Access Compliance Report

Public Rights-of-Way

Intersection ID: 46803	Main Street: FOUNTAINGROVE_DR	Cross Street: CLAUDE_FREEMAN_DR	Location: SE
ADA ID: B91D661610F8	Ramp Type: PerpDiag	Initial Pass/Fail: Pass	Overall Compliance: No
Codes/Mitigation Info/Possible Solution		Field Measurements/Component Compliance	
Severity Score: 14

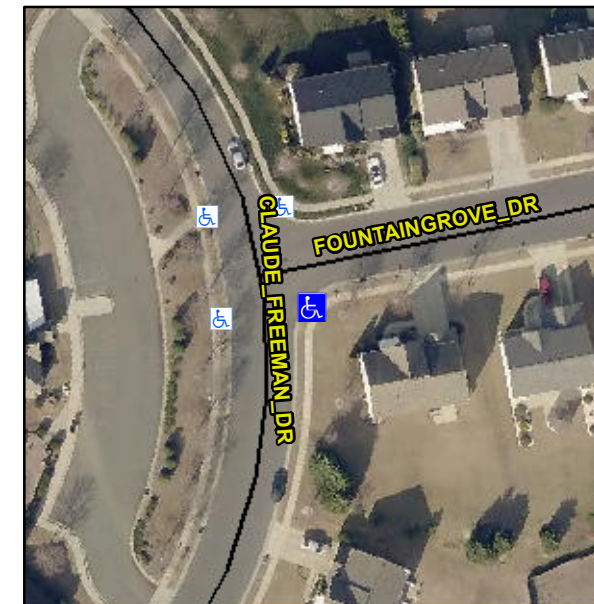
Not Found, R304.2.1, R305

Compliance	Description	Data	Compliance	Description	Data
N/A	Ramp Length (in)	47.5	Yes	Ramp Slope (%)	7.3
Yes	Ramp Width (in)	57.5	Yes	Ramp XSlope (%)	0.2
N/A	Flare Type LT	None	N/A	Flare Type RT	N/A
N/A	Flare Slope LT (%)	N/A	N/A	Flare Slope RT (%)	N/A
N/A	Flare Traversable LT?	N/A	N/A	Flare Traversable RT?	N/A
No	Landing Length (in)	47.0	No	DWS Provided?	No
No	Landing Width (in)	43.0	N/A	DWS Contrast?	No
Yes	Landing Slope (%)	0.8	N/A	DWS Length (in)	N/A
Yes	Landing X Slope (%)	0.5	N/A	DWS Full Width?	No
N/A	Landing Curb? (Y/N)	No	N/A	DWS Offset (in)	N/A
N/A	Shared Landing?	No			
Yes	Gutter Ponding?	No	Yes	Gutter Slope (%)	3.5
Yes	Gutter Lip Ht (in)	0.0	Yes	Gutter X Slope (%)	0.4
N/A	Painted X Walk1?	No	N/A	Painted X Walk2?	No
	X Walk 1 Direction	To N		X Walk 2 Direction	To W
N/A	X Walk 1 Width (in)	N/A	N/A	X Walk 2 Width (in)	N/A
	X Walk 1 Slope (%)	0.4		X Walk 2 Slope (%)	0.5
	X Walk 1 X Slope (%)	0.0		X Walk 2 X Slope (%)	0.3

Remove & Replace Curb Ramp With Two New Directional Ramps or Equivalent.
